**NSLPP MEETING HELD ON 03/04/24  
SECTION 4.56 APPLICATION REPORT**

**ADDRESS:** 96-98 Ben Boyd Road, Neutral Bay

**APPLICATION No:** DA 86/2022/03

**PROPOSAL:** Modification of Court Approved residential flat building (DA86/22) to provide for an amended balcony design to the southern and western elevations of an approved residential flat building and satisfy the intent of Condition C51 Balconies – Design Amendments

**Figures 8, 9 & 10 – LEC Approved Level 1 Floor Plan, DA 2003 Rev C (left), Annotated Level 1 Floor Plan, DA 2003 Rev F approved by NSLPP (middle) and Amended Level 1 Floor Plan, DA 2003 Rev H (right)**

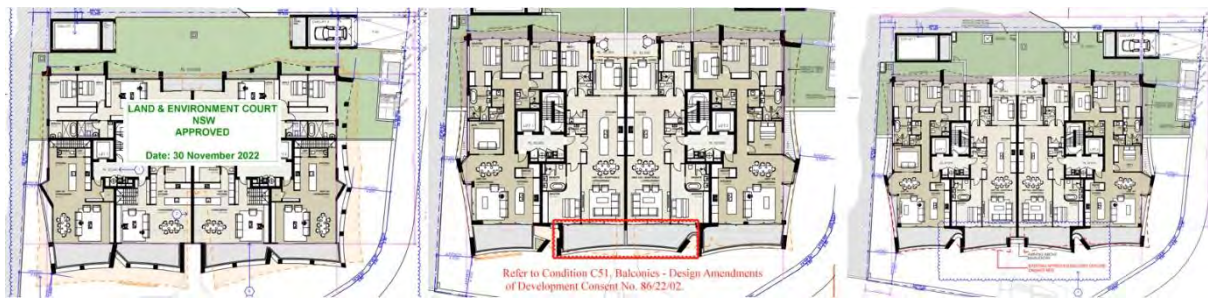
It is however noted that the amended balconies are not strictly designed as per that approved under DA 86/22 – LEC No. 2022/165233 therefore requiring determination by the Panel. The below figures provide a visual understanding between the plans approved by the LEC, those lodged subject to the previous modification and the current amended balconies. It is noted the current southern balconies especially the centrally sited balconies have an improved articulation and break in form compared to the previous modification.

In summary, the proposed plans with amendments to the southern balconies and the Level 5 western balcony although not being of a matching design compared to the balconies approved by the LEC are sufficient to satisfy the intent of Condition C51 Balconies – Design Amendments.

**DRAWING TITLE:**  
**LEVEL 1 FLOOR PLAN**  
 PROJECT ADDRESS: **96-98 BEN BOYD RD, NEUTRAL BAY NSW 2089**  
 APPLICANT: **AIDOP NO 3 PTY LTD SUITE 506, LEVEL 5, 55 MILLER ST, PYRMONT NSW 2009**

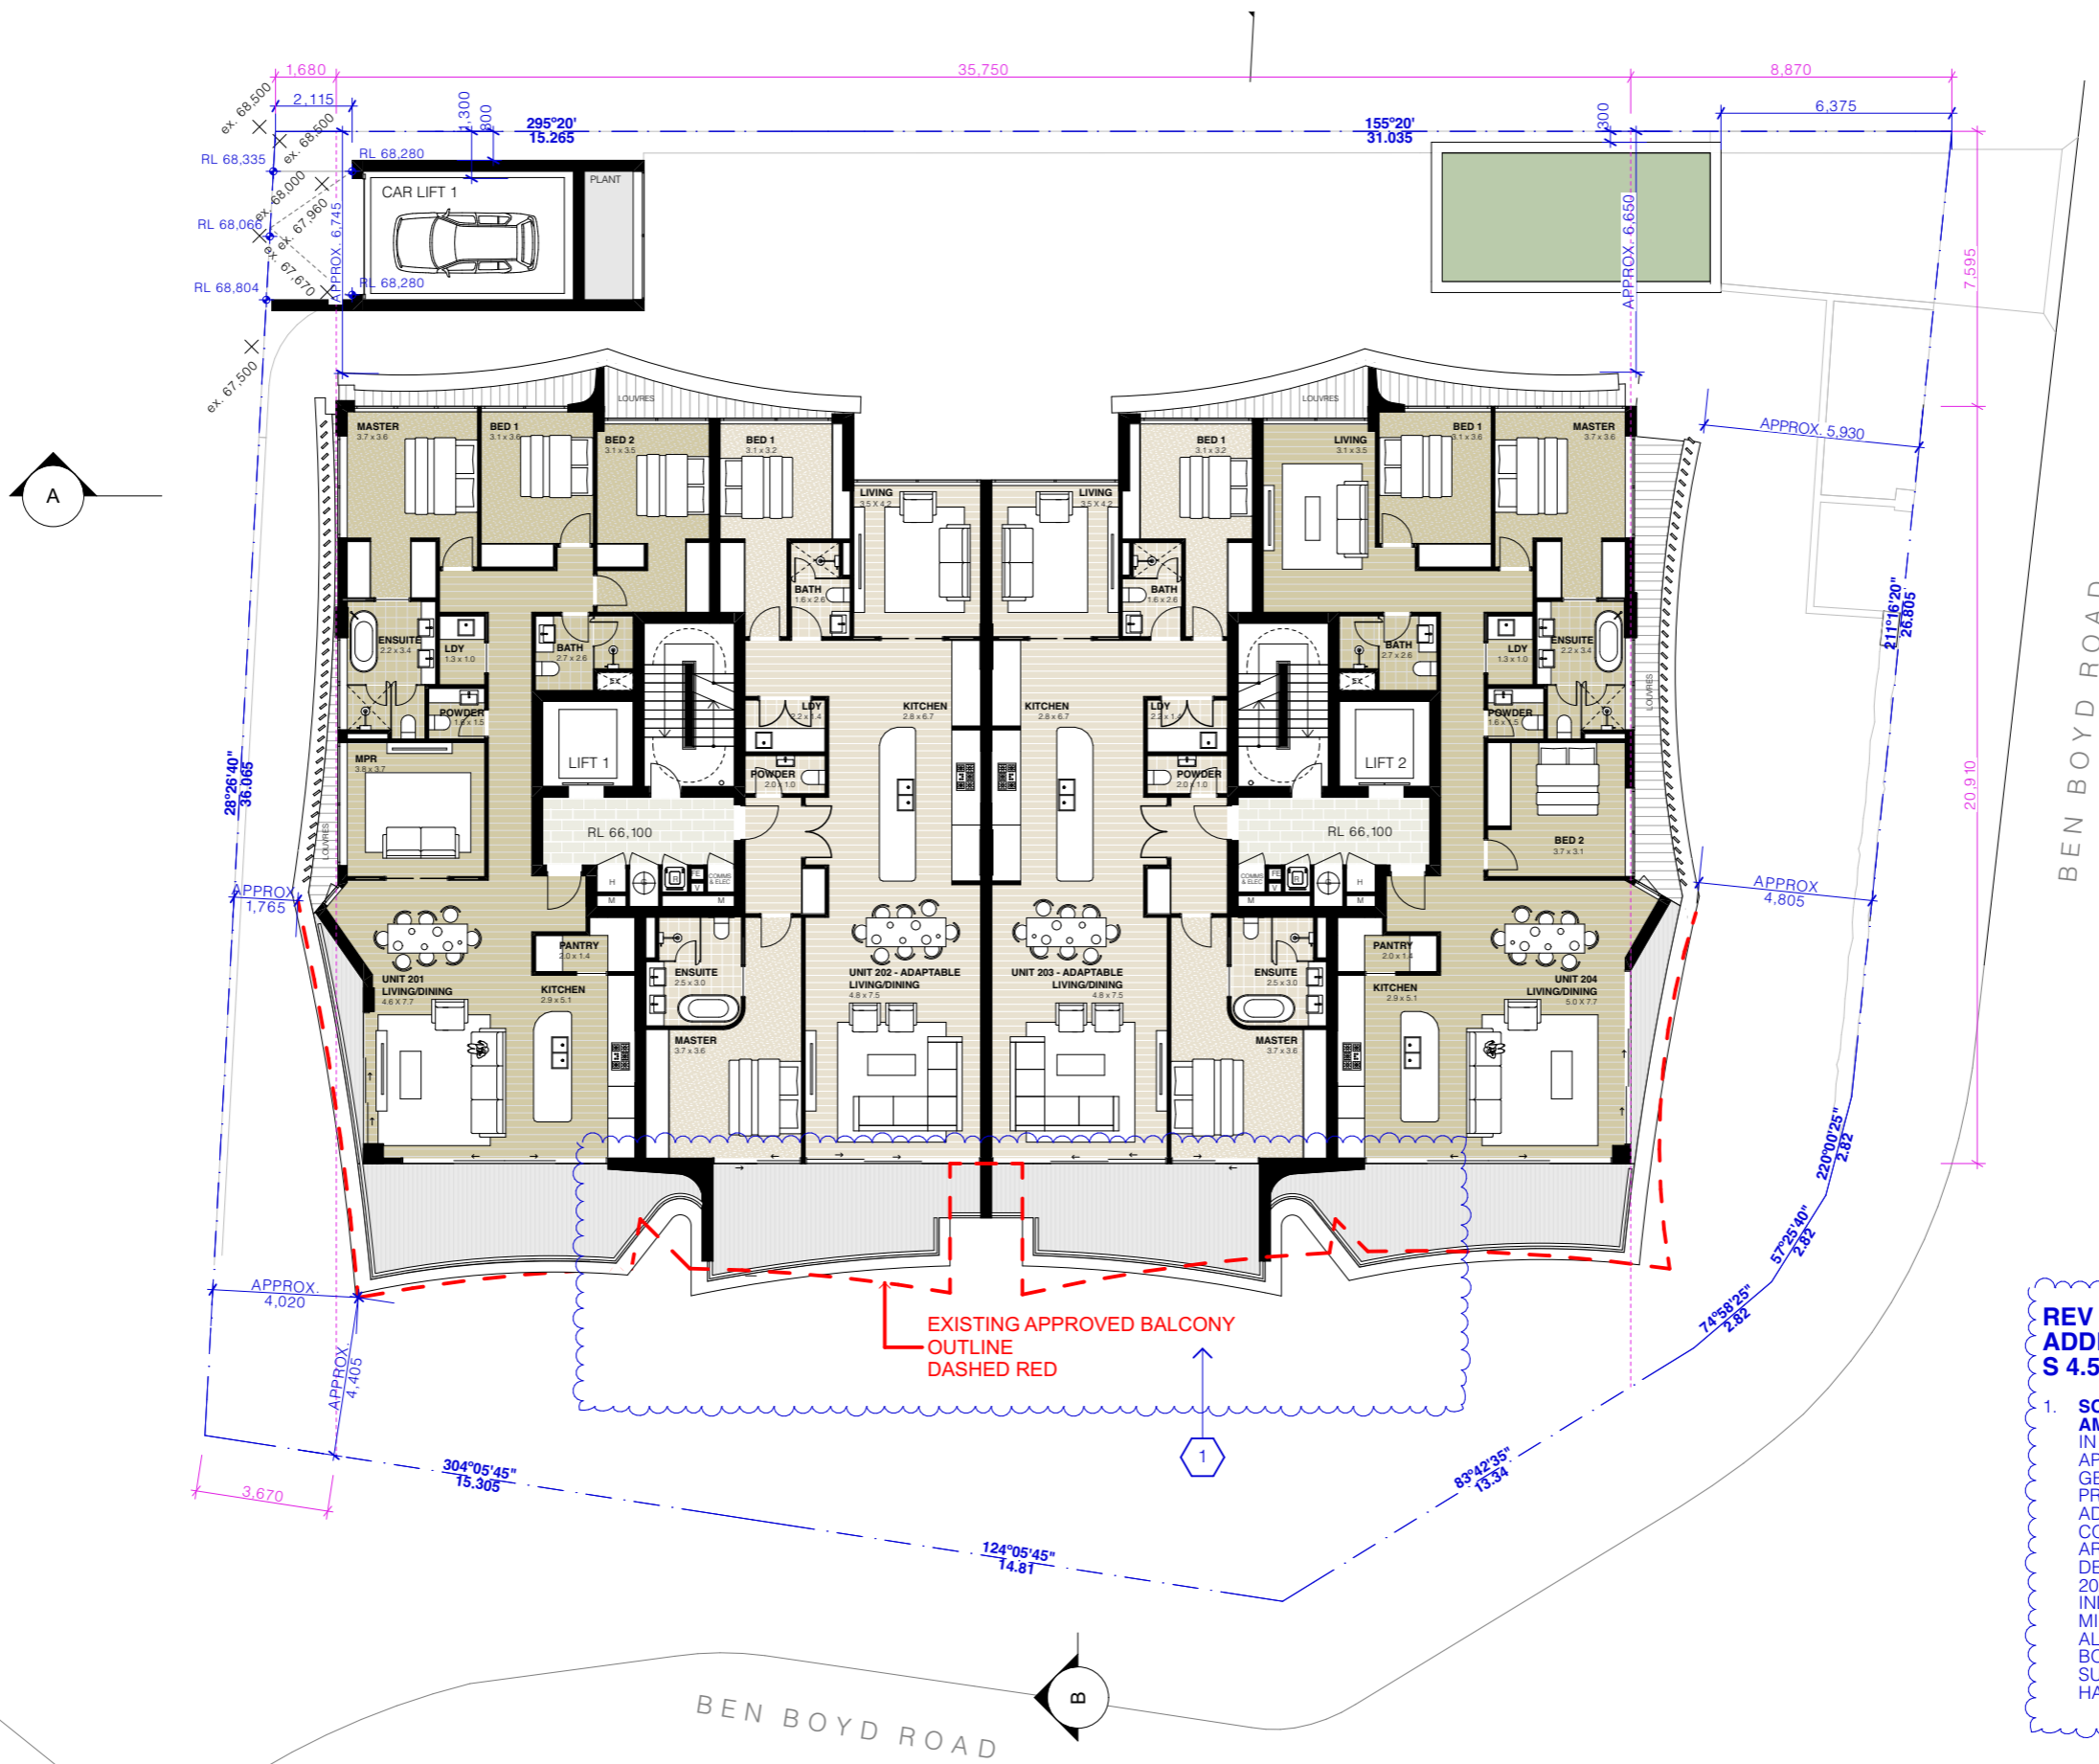
- SOUTHERN FACADE BALCONIES - DESIGN AMENDMENTS:**  
 IN LINE WITH THE UPDATED APARTMENT LAYOUTS APPROVED UNDER S4.56 (86/22/2), BALCONY GEOMETRY HAS BEEN RECONFIGURED. THE PROPOSED FACADE TREATMENT, AIMED AT ADDRESSING NSLPP CONCERNS (SPECIFICALLY CONDITION C51), NOW INCLUDES REVISED ARTICULATION, AKIN TO THAT APPROVED IN THE DETERMINATION FOR DA 86/22 - LEC NO. 2022/165233. THIS INVOLVES A CENTRAL INDENTATION, WITH ADJACENT BALCONIES MIRRORED TO ENSURE A SYMMETRICAL DESIGN ALONG THE SOUTHERN BOUNDARY FACING BEN BOYD ROAD. ADDITIONALLY, THE WINDOWS AND SURROUNDING FEATURES HAVE BEEN UPDATED IN HARMONY WITH THESE BALCONY ALTERATIONS.

**S34 APPROVED PERSPECTIVE**

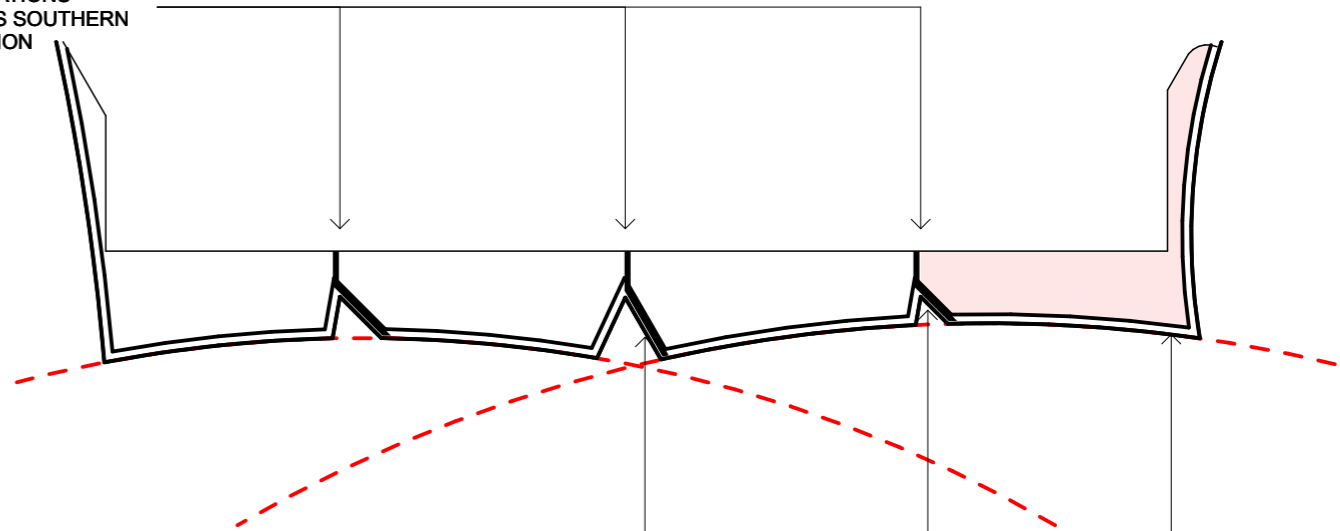
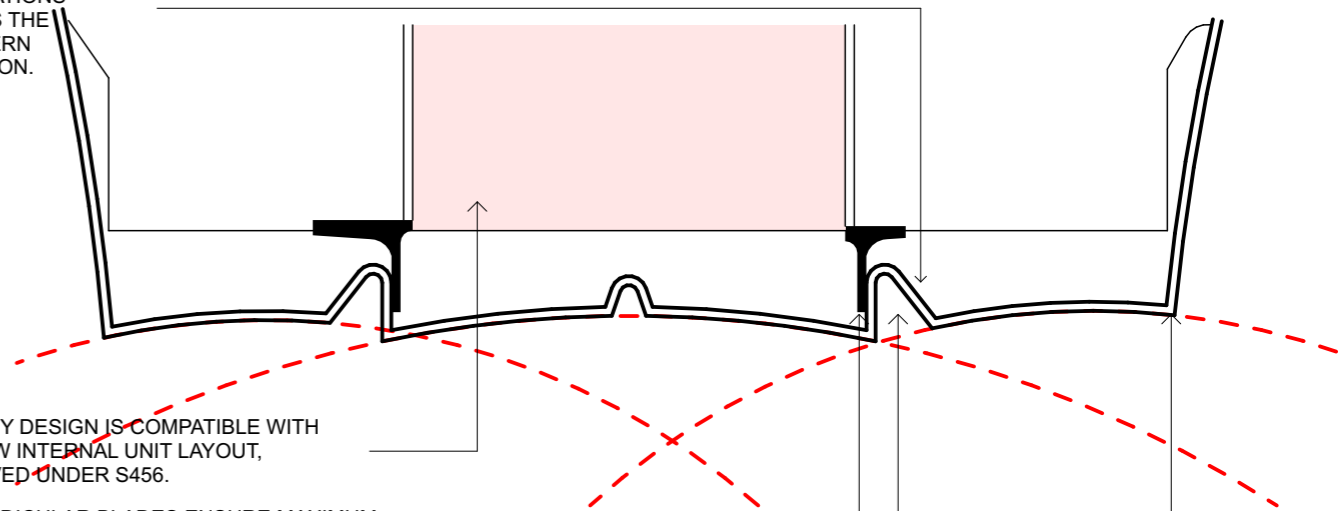
The design changes we have made to the South-facing balconies as a result of feedback from the NSLPP maintain a commitment to the building's aesthetic and structural integrity, and with a continued commitment to the original principles set forth in the original DA. The changes proposed in this revision are minor in nature, retaining the integrity of the massing and proportions approved post-S34, whilst enhancing spatial distribution along the façade. This design response is also complementary to the updated apartment layouts on levels 4 and 5, in accord with the S4.56 approval. This results in a more harmonious and visually appealing connection between the living spaces and their respective balconies, elevating the residential experience and magnifying the harbour views.

**S34 APPROVED PLAN**

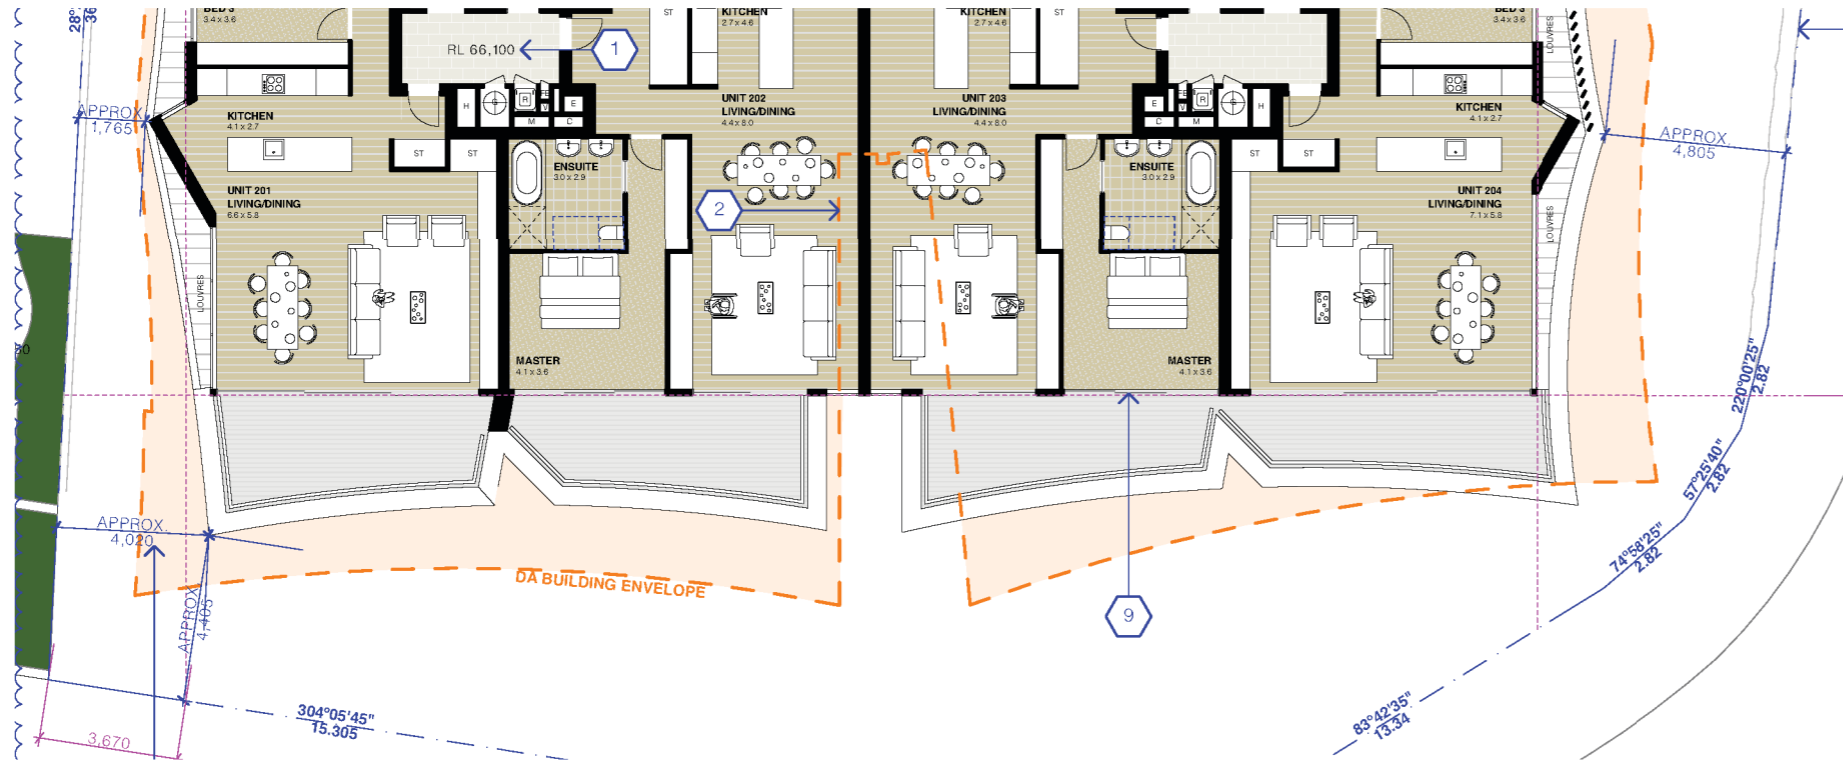
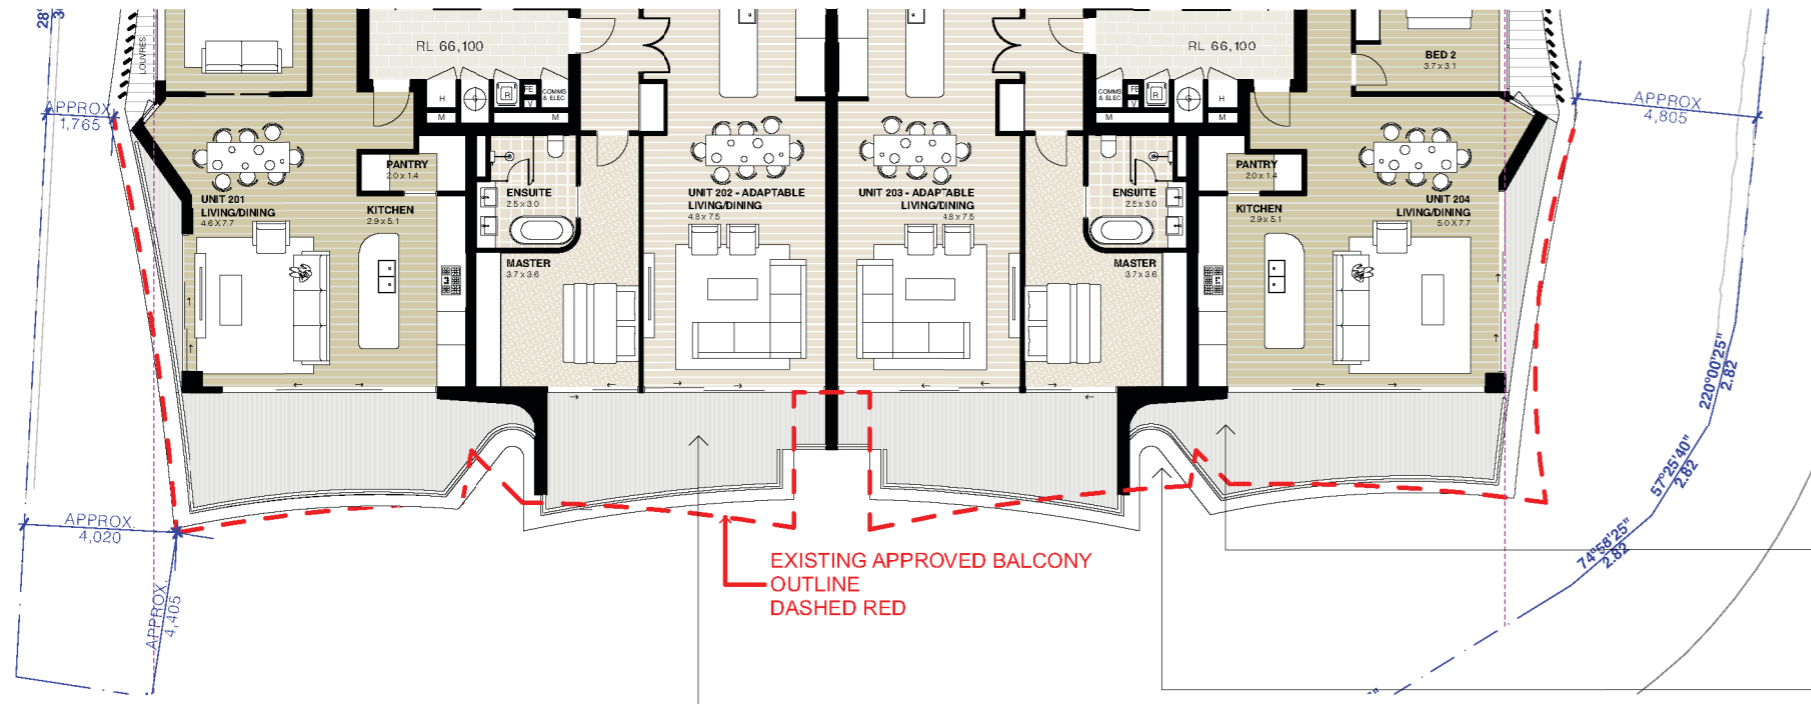
BALCONY SIZES MORE UNIFORM IN AREA AND DEPTH ALLOWING EQUITABLE EXTERNAL PRIVATE SPACE TO ALL UNITS. OUTCOME IS SYMMETRICAL WHICH MATCHES DESIGN INTENT OF S34 APPROVAL

**S34 APPROVED PLAN**

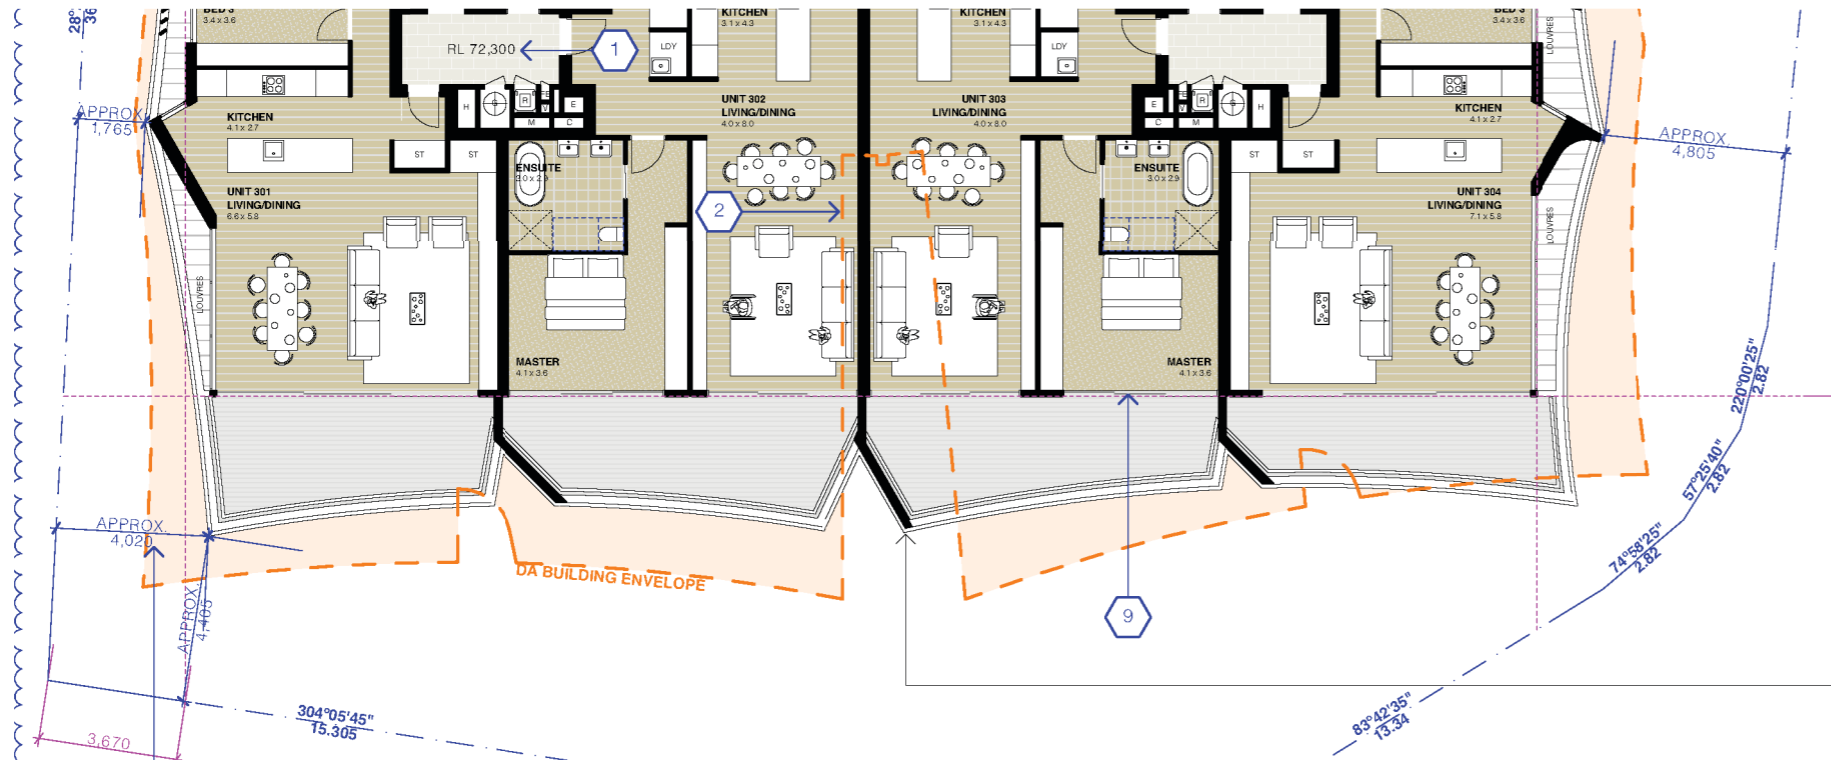
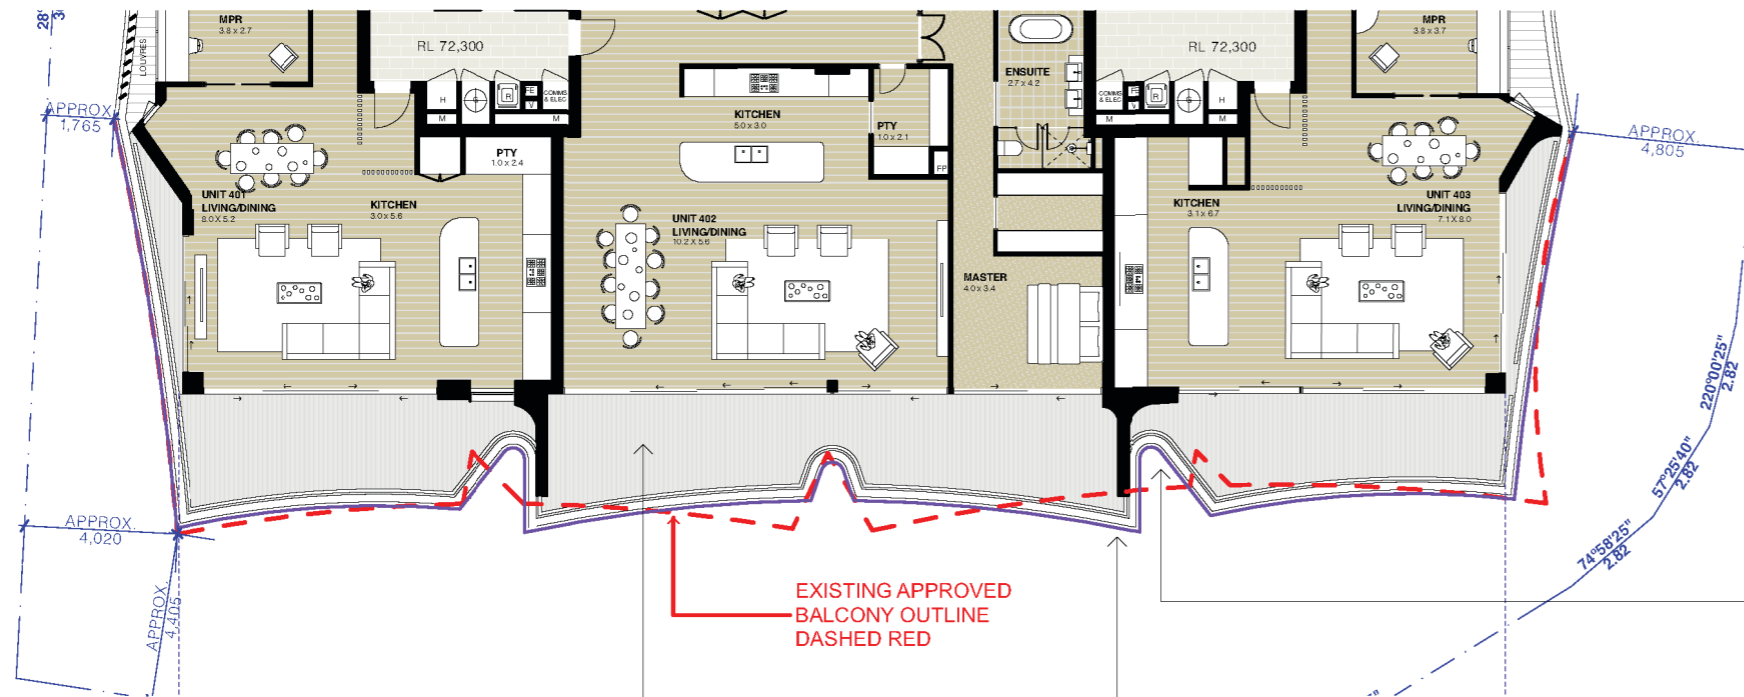
S34 PLANS INCLUDED ANGULAR BLADES WHICH PROVIDE PRIVACY BETWEEN UNITS HOWEVER BLOCK VIEWS OF HARBOUR AND REDUCE DAYLIGHT

EXISTING APPROVED BALCONY OUTLINE DASHED RED
